## City of Sebastopol Design Review Board Staff Report

Meeting Date: May 20, 2020  
Agenda Item: 6b  
To: Tree Board  
From: Alan Montes, Associate Planner  
Subject: Tree Removal Permit  
Recommendation: Approval with Conditions  
Applicant/Owner: David Fowler (Applicant)/Carol Rogers (Property Manager for HOA)  
File Number: 2020-027  
Address: 8301 + 8311 Valley View Court  
CEQA Status: Categorical Exemption: Section 15304: Class 4  
General Plan: High Density Residential (HDR)  
Zoning: Planned Community (PC)

**Exhibit A**  
**TREE REMOVAL PERMIT**  
**8301 + 8311 Valley View Court**  
**Removal of Protected Trees**

ARBORIST'S REPORT  
8301-8311 Valley View Ct - Sebastopol  
April 6, 2020

L1

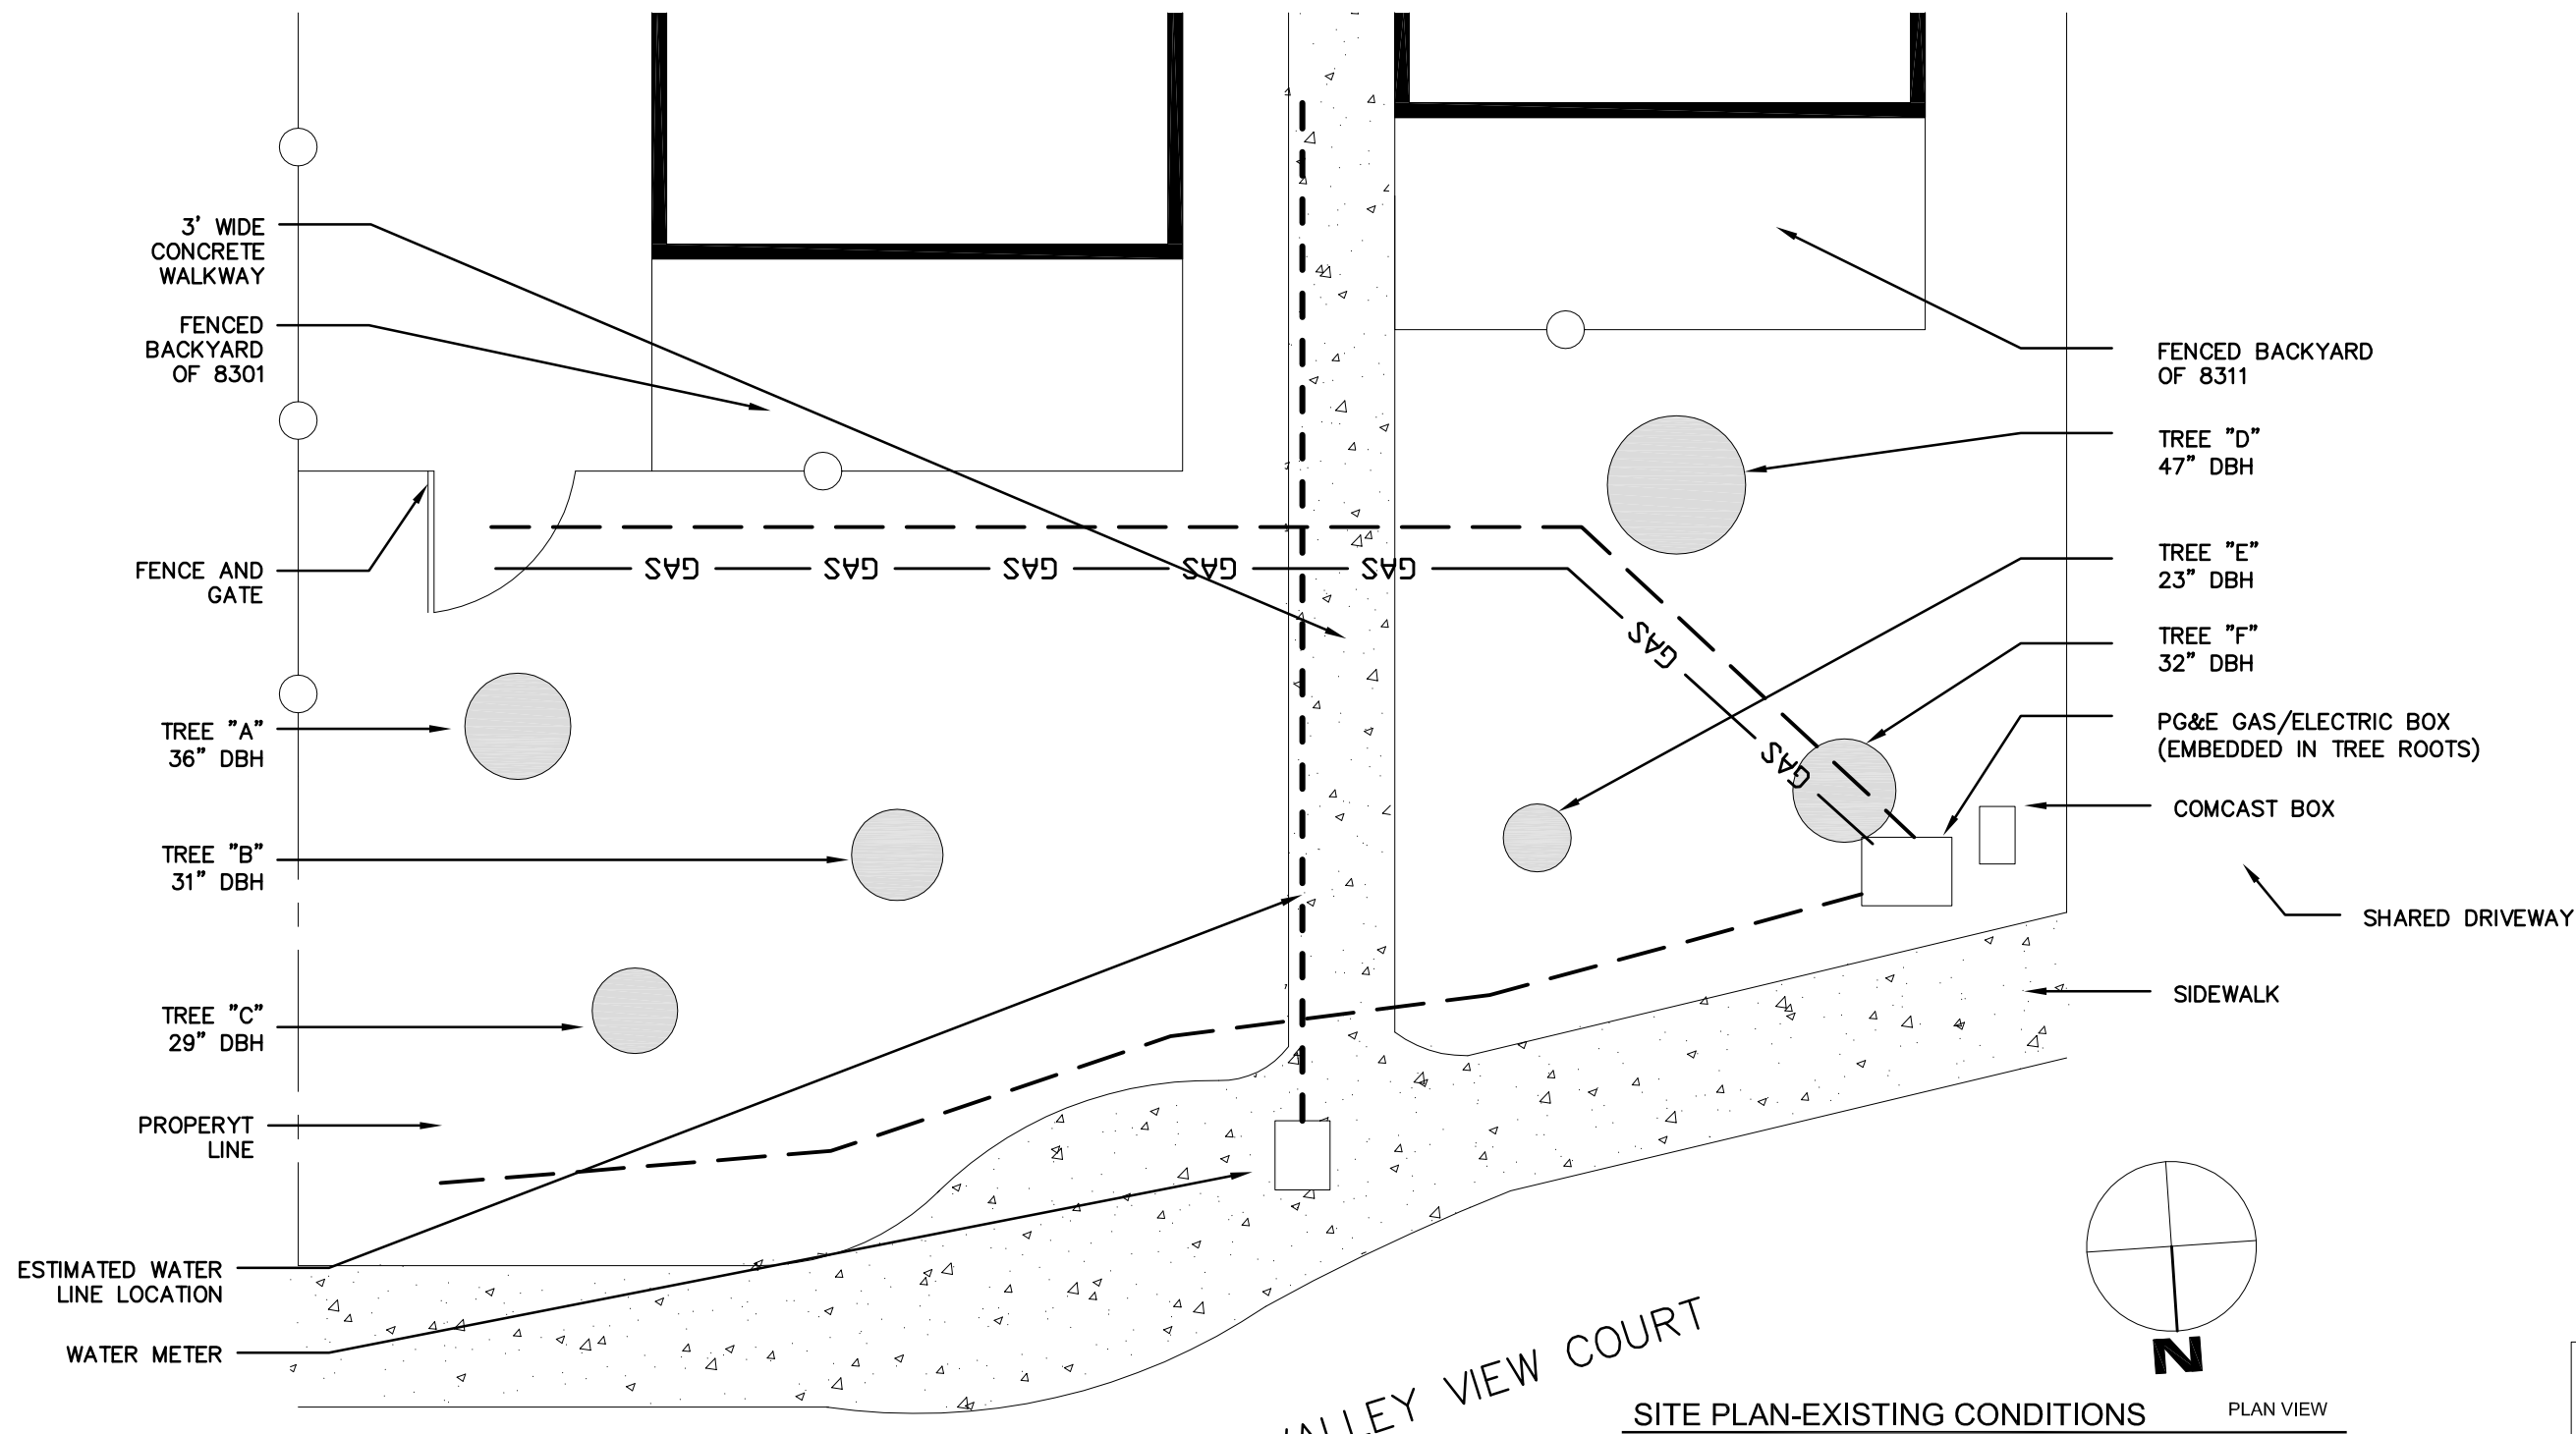
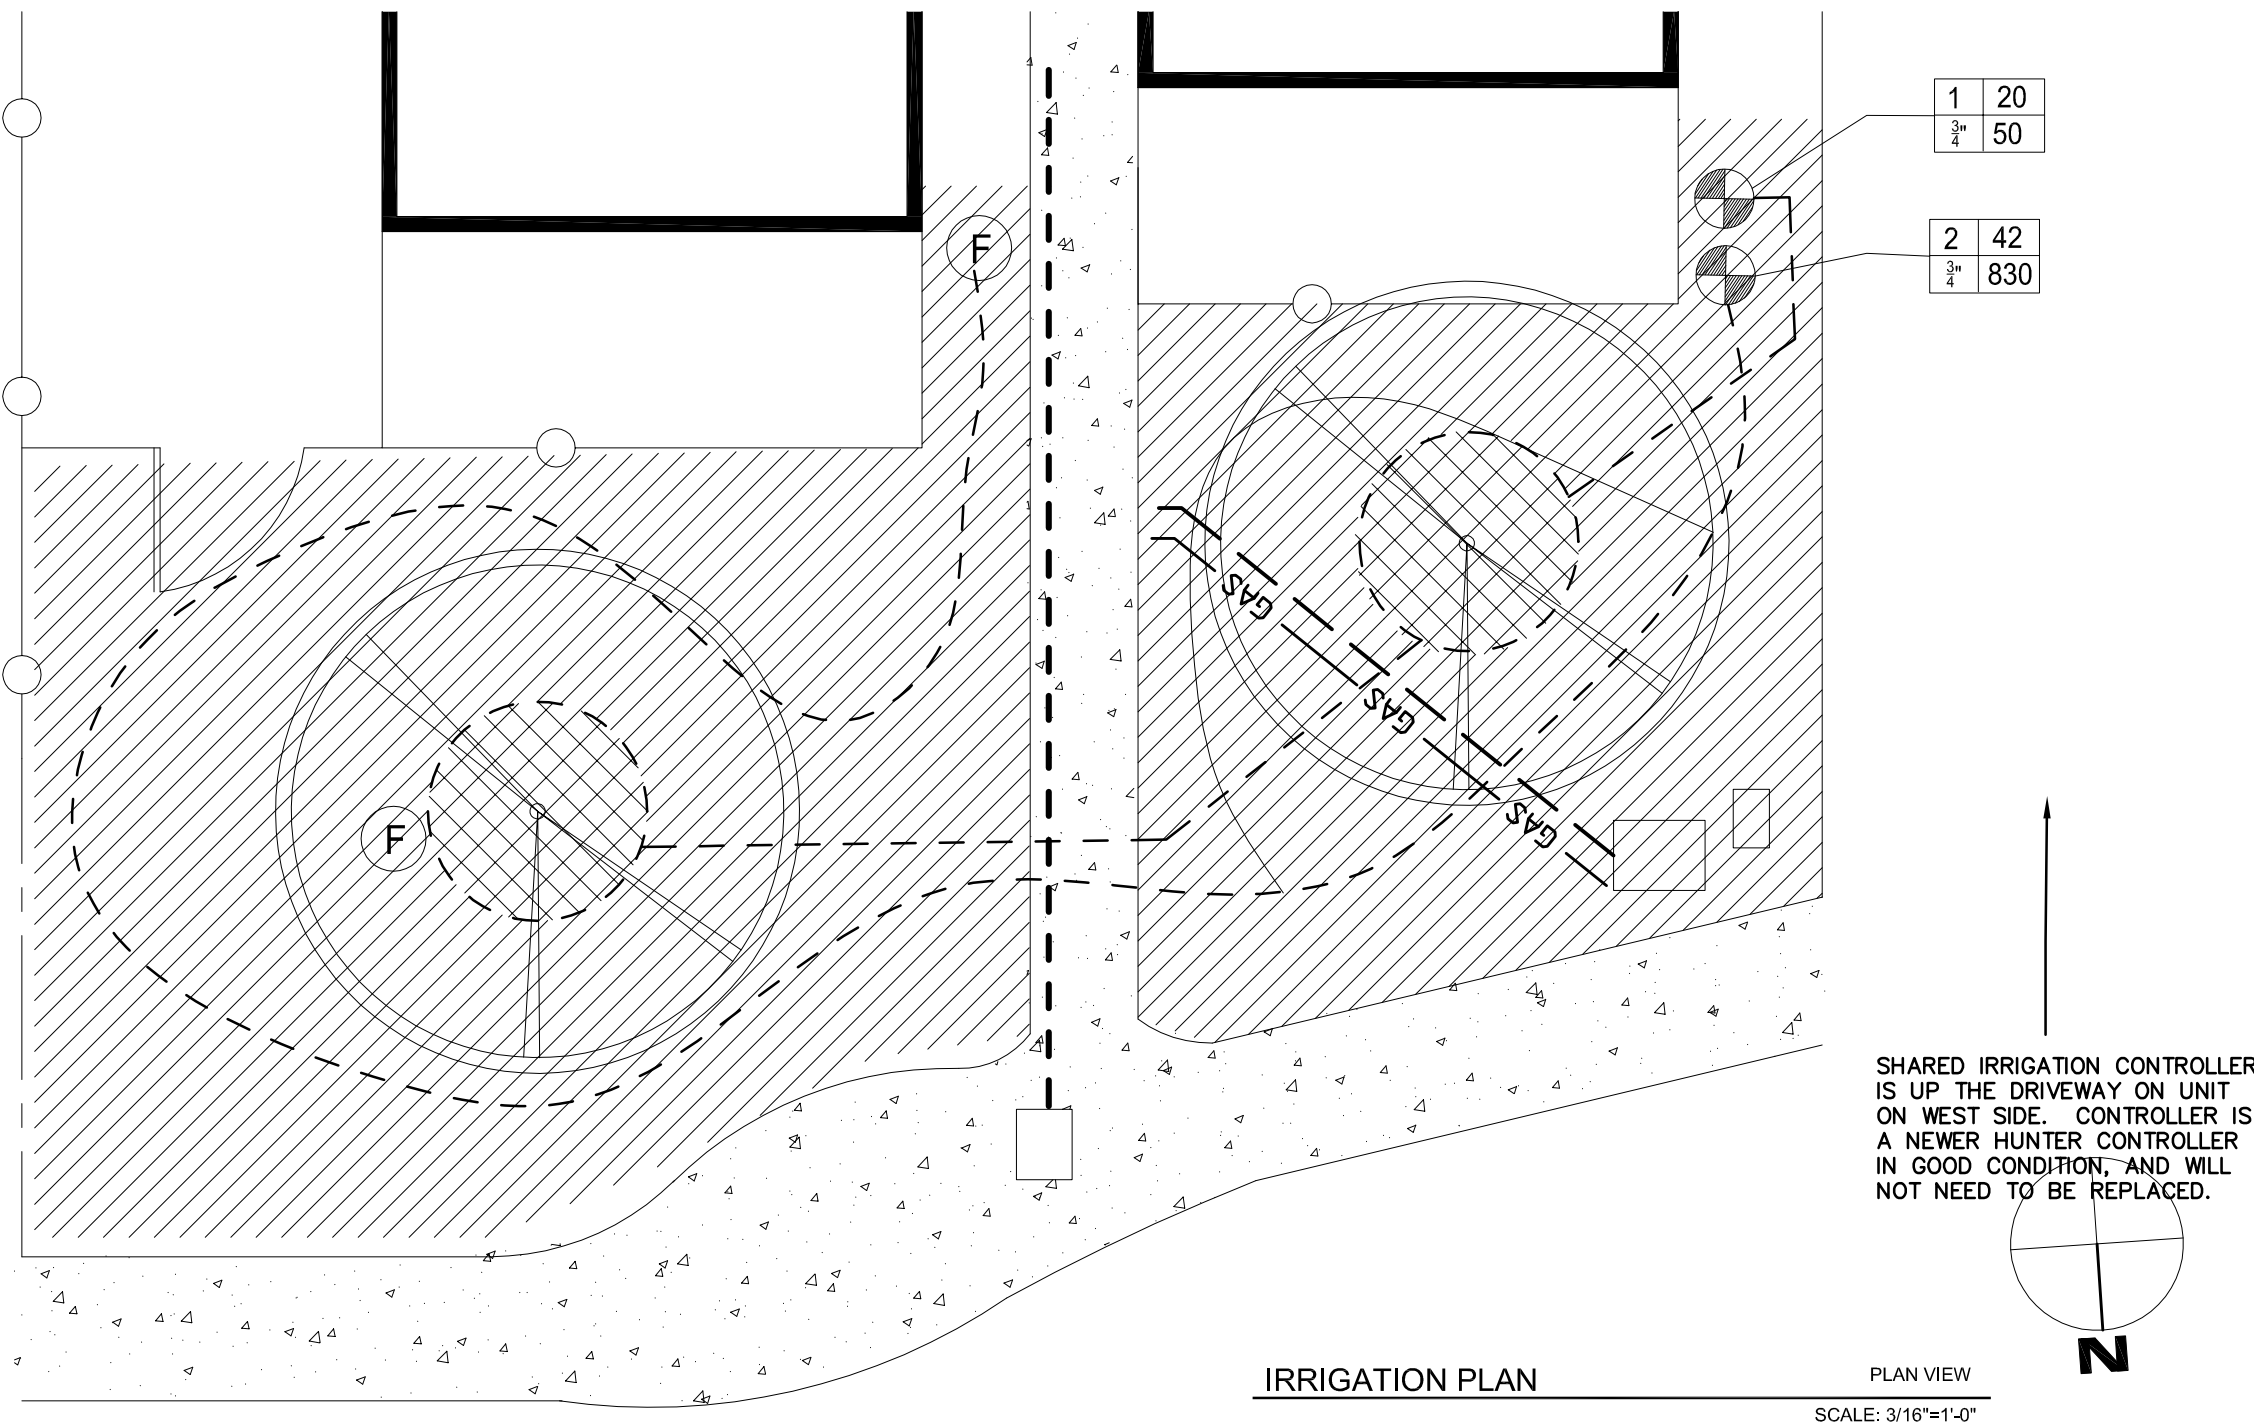
I visited this site on April 2nd at the request of the Planning Dept. to evaluate six coast redwoods (*Sequoia sempervirens*) growing in small planter areas at Green Valley Vista on Valley View Dr.. All six trees are proposed for removal. There are other large redwoods in similar locations in this townhouse complex, though these are the only ones being proposed for removal right now.

They are growing in front of two of the units, 8301 & 8311 Valley View Ct. Roots from all six redwoods have already visibly caused damage to the adjacent sidewalk (which has been repaired), as well as growing into the utility boxes and lines mentioned in David Fowler's report.

I agree that these trees are a species that is inappropriate for these confined spaces. Landscape architects in the '80's had different concepts of tree selection and growth than informed ones do now.

In regard to replacements, one of the main goals of Sebastopol's Tree Ordinance is to protect trees in the community which provide valuable assets such as shade, privacy screening, etc. The proposed replacement trees are Catawba crape myrtle (*Lagerstroemia indica* 'Catawba'). This shrubby smaller crape myrtle species is susceptible to powdery mildew (a fungal disease) in this area. I agree that large shade trees would grow too large for the spaces proposed, but I recommend specifying a larger crape myrtle. Any of the hybrids with names such as Natchez and Muskogee are larger and upright (when trained properly) and will be closer to 25' in height when mature – an appropriate size for these locations.

As far as the requirement for a 1:1 replacement instead of Sebastopol's 2:1, I think it makes sense on this site with tight spaces but the City will probably require in-lieu fees for the trees not installed. You can discuss that with staff.
